Meeting Date:
April 18, 2024

Location:
166 Ravenna St

Request
A variance request for a side yard setback

PROJECT: DEMO AND BUILD 20'X20' DETACHED GARAGE

SITE PLAN

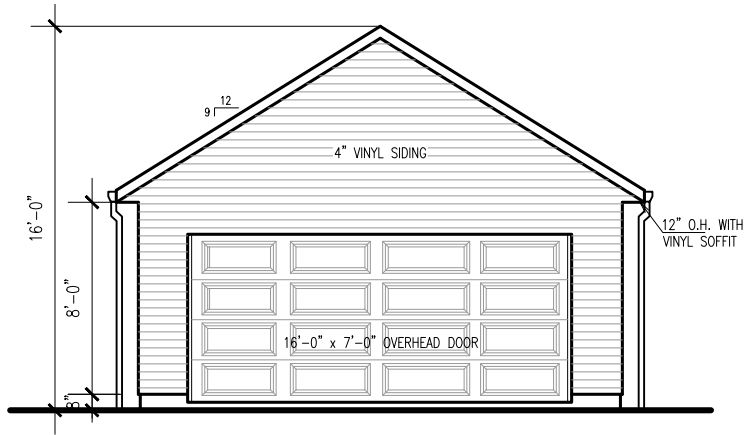
Staff acknowledges an enclosed garage is significant to provide reasonable return and beneficial use of the property and some amount of variance may be justified; however, staff questions if the application has sufficiently documented the need for a substantial thirteen (13) foot variance, as further discussed in this analysis.

- Staff notes the presence of both communication and overhead utility lines on the property. These lines, per a site visit with Hudson Public Power, would need to be relocated before construction could begin on the proposed project. This item would be coordinated through the administrative site plan review.

Staff questions if the garage could be sited further to the rear of the property to allow the room for the drive to be angled and increase the side yard setback. Staff notes the rear yard setback for accessory structures is fifteen (15) feet.
